Drainage Assessment - Event Parking Area.

50 Peter Brock Drive, Eastern Creek,
NSW

P2108122JR02V01

Response to DPIE RFI

TYPICAL BIORETENTION BASIN PROFILE AND SEDIMENT PIT DETAIL
NOT TO SCALE

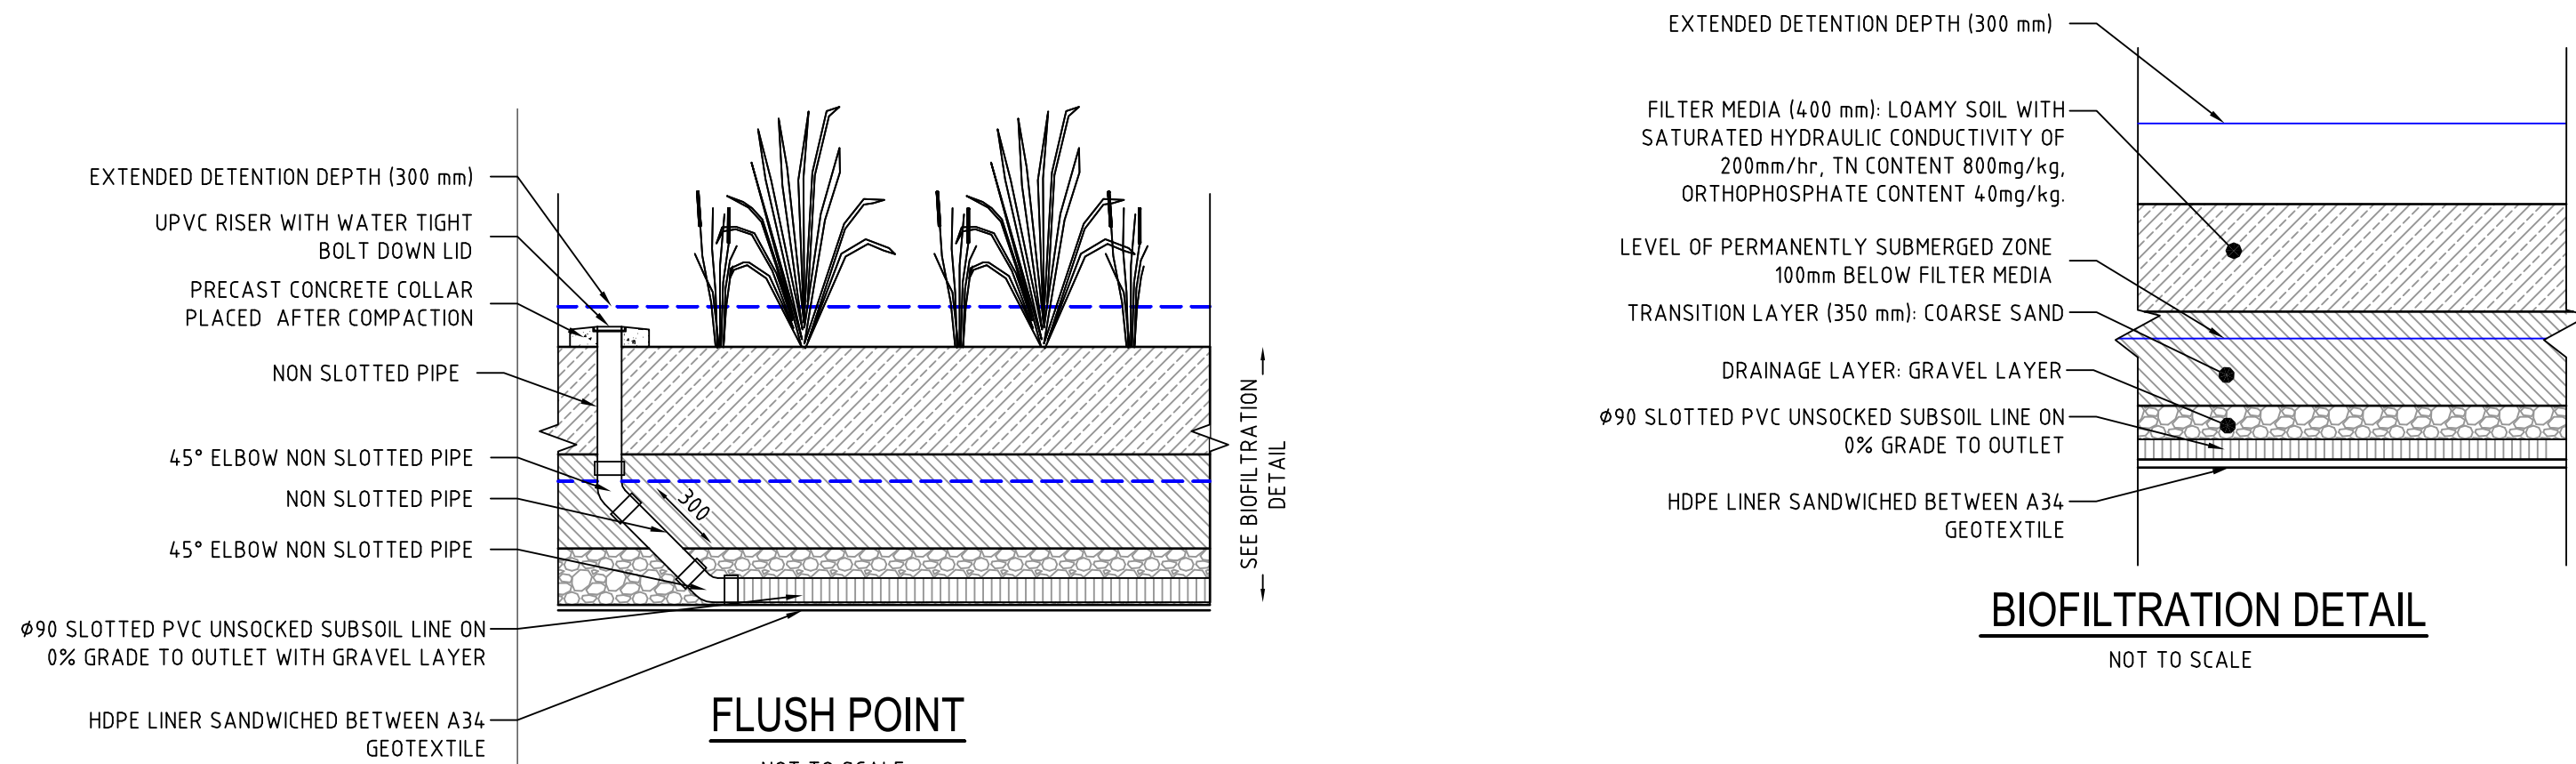
7.5 Water Quality <i>Having regard to changes in surface finish, a water quality treatment system is to be designed by the Engineer in accordance with Council's MUSIC water quality conceptualisation model and submitted for further consideration.</i>	A water quality system is included within the design of the drainage system for Event Parking Area in accordance with BCC's MUSIC guidelines to treat the pollution generated from the changes in surface finished proposed by the development. Refer to Section 2 for further details.

A bioretention basin is proposed for the site, providing tertiary treatment removing pollutants via filtration, adsorption and biological uptake. Refer to MA planset P2108122PS01 drawing PS01-E100 for the basin location and drawing PS01-E201 for basin details.

DRAWING TITLE				
DRAINAGE DETAILS SHEET 3				
PROJECT NO.	PLANSET NO.	RELEASE NO.	DRAWING NO.	REVISION
P2108122	PS01	R02	PS01-E202	A

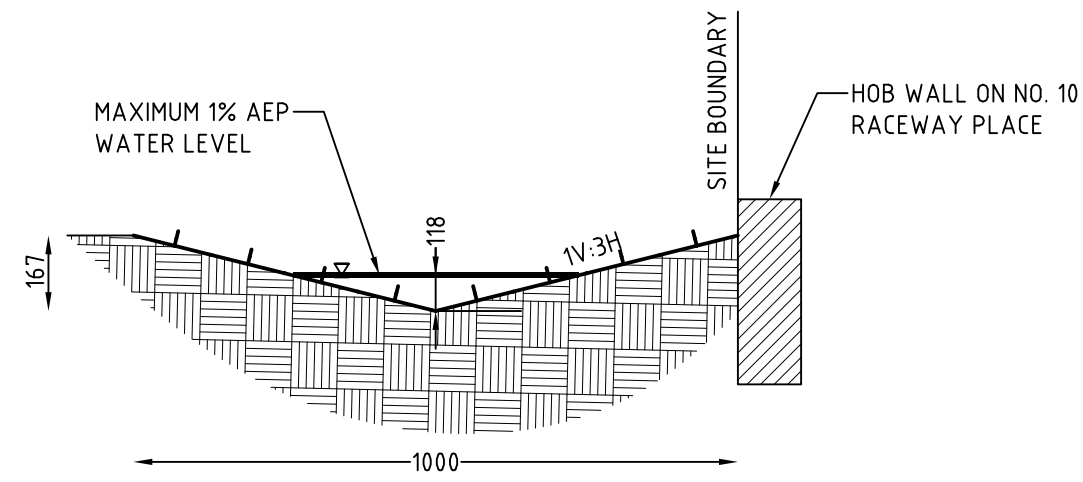
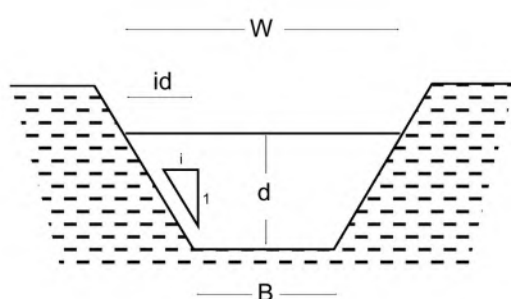
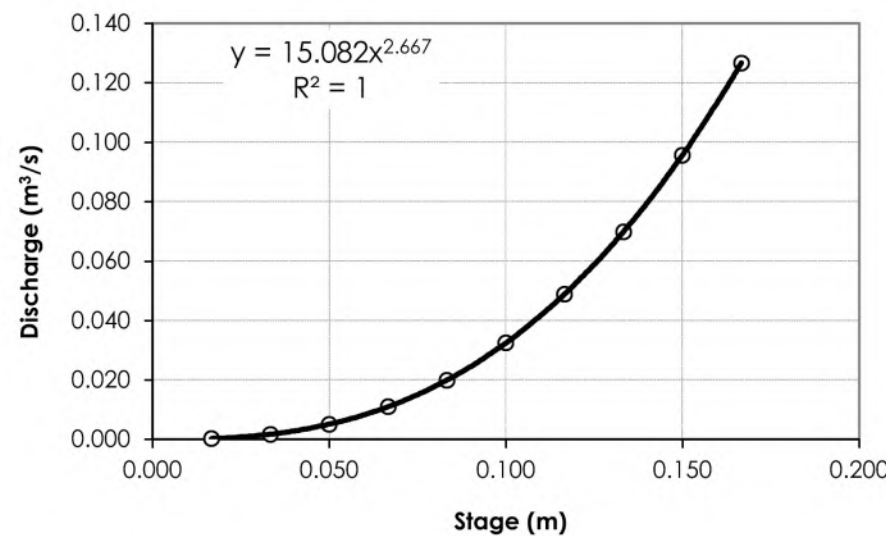
RFI Issue	Response / Comment
7.2 Eastern Swale <i>Submissions appear to show the eastern side batter of the fill work is graded directly to the existing level on the common boundary and/or very overgrown, impacting on its runoff carrying capacity. In this regard, please provide hydrologic calculations for the 100 year average recurrence interval (ARI) stormflow to the swale on the common boundary with No. 10 Raceway Place to ensure safe disposal with event parking overland drainage systems directed to the west. Provide channel calculations to indicate design flow velocity, depth and width at the most conservative chainage. Provide 500 mm freeboard between the design flow water level and existing surface level on the common boundary.</i> <i>Design a swale at appropriate scale showing how the swale design matches with existing levels. Levels and batter grades for the existing and post-development case must be shown. Where a swale is proposed to be traversed by a design vehicle (which may be a commercial service vehicle or an Endeavour Energy designated vehicle), provide a longitudinal section through the traverse and using an appropriate guideline such as AS 2890.2 :2002 Section 3.3.3 show how the design vehicle avoids scraping.</i>	The catchment area to the swale has been reduced and does not form a key element of the design as upslope flows are conveyed within the central drainage line through the site. Flow calculations are detailed in plan PS01-E202 (refer also to section 2.2). Freeboard is in accordance with BCC requirements for minor drainage systems. Detailed levels for the swale are provided in the civil plans.

1. The swale catchment consists only of the carpark fill batter to the west and does not receive any upstream flows. In doing so, only very small quantities of water are contained and passed through the swale.
2. The swale has maximum internal batter slopes at 1 in 3 and a top width of 1 m.

3. The capacity of the swale has been sized to convey the 1% AEP flow.

Swale details and calculations are provided in Attachment D drawing PS01-E202.
